Item 7.**Development Application: 5-15 Dunning Avenue, Rosebery - D/2019/390****File No.:** D/2019/390**Summary**

Summary Recommendation: The development application is recommended for approval, subject to conditions.

Figure 49: Section through buildings 2 and 3, showing height in storeys and 22m height limit

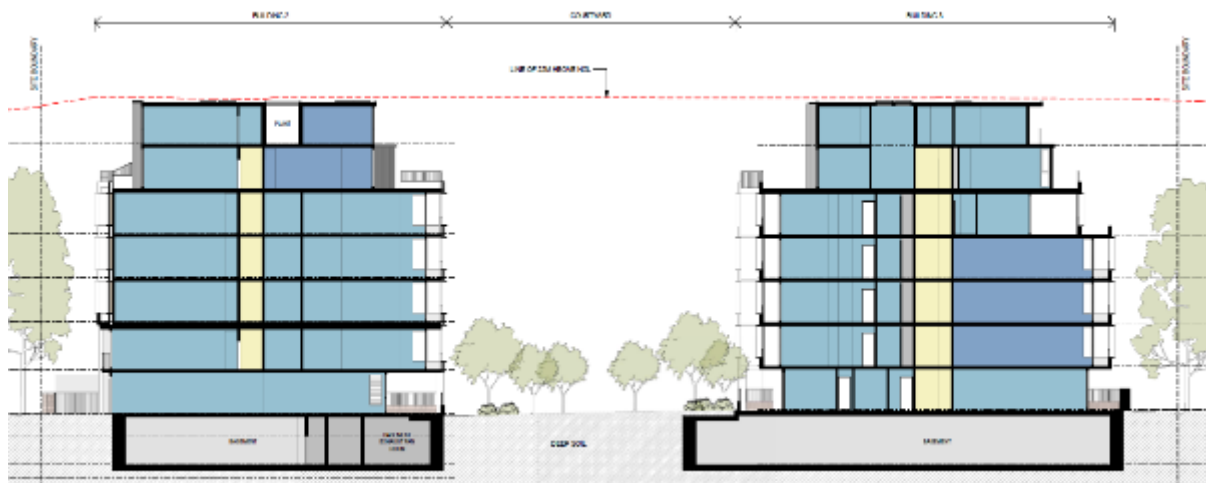
64. Section 4.2.1.1 of the Sydney DCP 2012 permits a maximum of six (6) storeys. The development proposes seven (7) storeys. This is shown in the figure below.

65. This numeric non-compliance is considered acceptable for the following reasons:
- The development is setback a minimum of 4.8-5 metres from the public domain, and the upper two storeys are setback an additional 2 metres. These setbacks reduce the perceptible bulk of the additional upper level.

- The proposal development sits within the permitted 22 metre height limit and includes spaces within level 7 for plant and services so they don't protrude above the height limit.

Figure 51: Apartment 1201

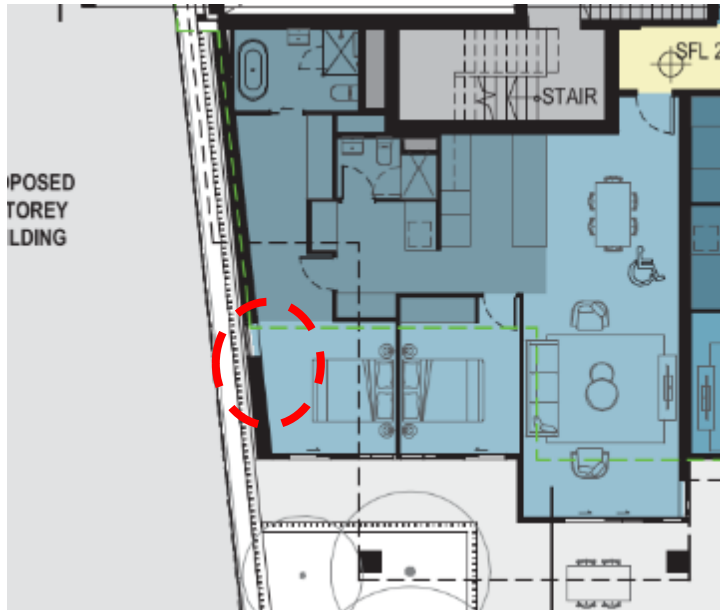
66. The proposal includes a secondary window on the southern side boundary in apartment 1201. This is shown in the figure below. This window is required to be deleted by condition. There is no easement proposed over this window to protect light and air, and the neighbouring development is proposed to be built to the boundary. As such, this window is recommended to be deleted by condition.

Figure 54: Southern facing apartment on levels 2 to 5 showing setback

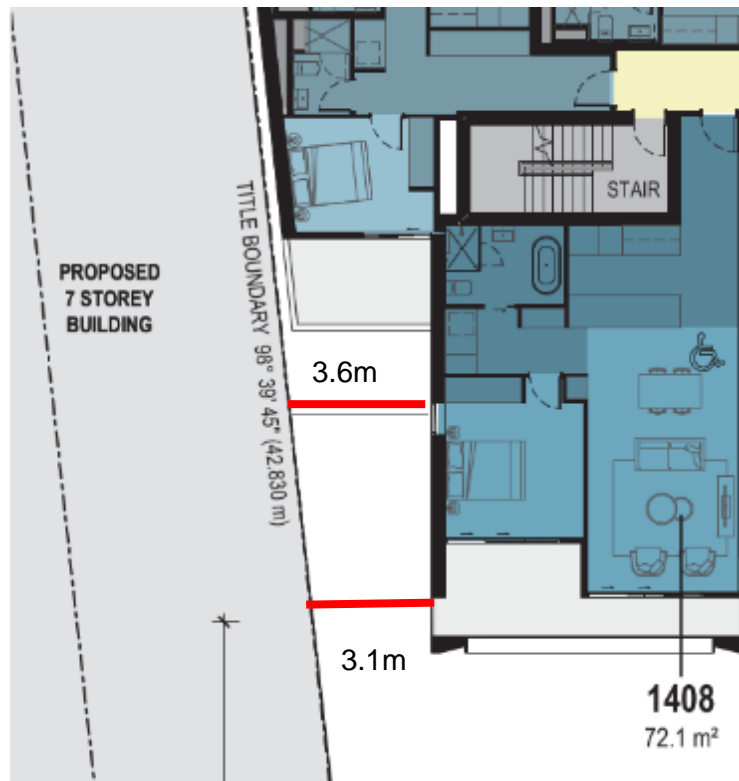
68. The development includes windows 3.6 metres from the south boundary. The ADG recommends a minimum setback of 6 metres for habitable openings. This is shown in the figures below.

69. Given the building to the south is proposed to be built to the boundary, it is likely this will be a blank wall and therefore have no openings. In addition to this, the window will be required to have a covering (hood or blade wall) which will further obstruct overlooking. The balcony is principally orientated towards the courtyard, subject to a condition requiring operable louvres being installed on the southern end of the balcony, this setback is considered acceptable.

Figure 54: Northern setback to boundary on levels 1 to 5 of building 2

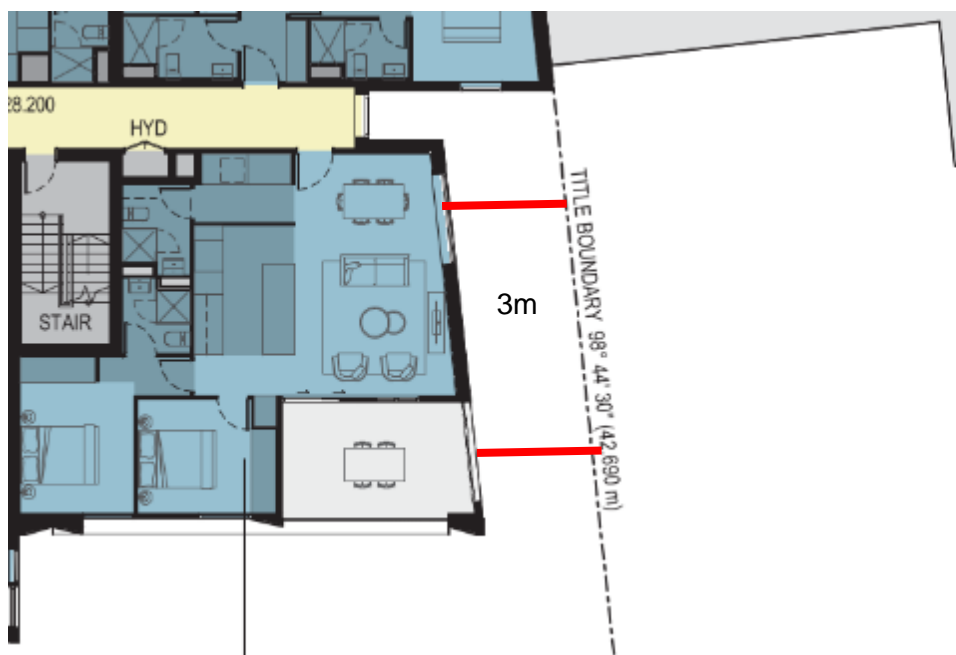
71. Building 2 includes windows and balcony openings 3 metres from the north boundary. This is shown in the figures below.

Figure 50: Setback/inboard bedroom window in building 3

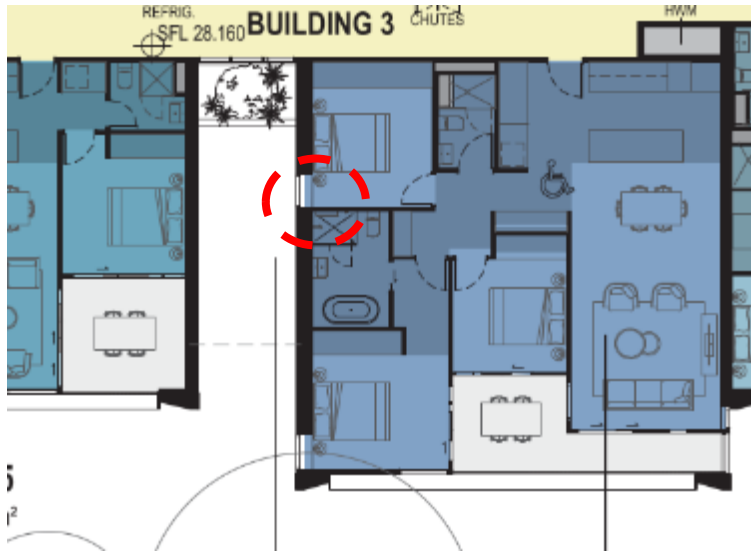
73. The proposal includes a bedroom window on levels 1 to 3 of building 3 which is setback from the street. This is shown in the figure below. The design of this apartment needs to be adjusted so that the rear bedroom has access to light and outlook. This can be done by increasing the bedroom size to accommodate an outward facing window and increase the size of raised planters to minimum 4 metre length (to match the bedroom), 1.5 metres wide and 800mm depth.

74. The increase in bedroom size will increase the GFA of the development by approximately 6m², which is still within the permitted FSR for the development. This additional floor area will also be added to the TFA amount for the affordable housing contribution.
75. Building 3 includes habitable openings and balcony openings 3 metres from the northern boundary. The ADG recommends a minimum setback of 6 metres for habitable openings.
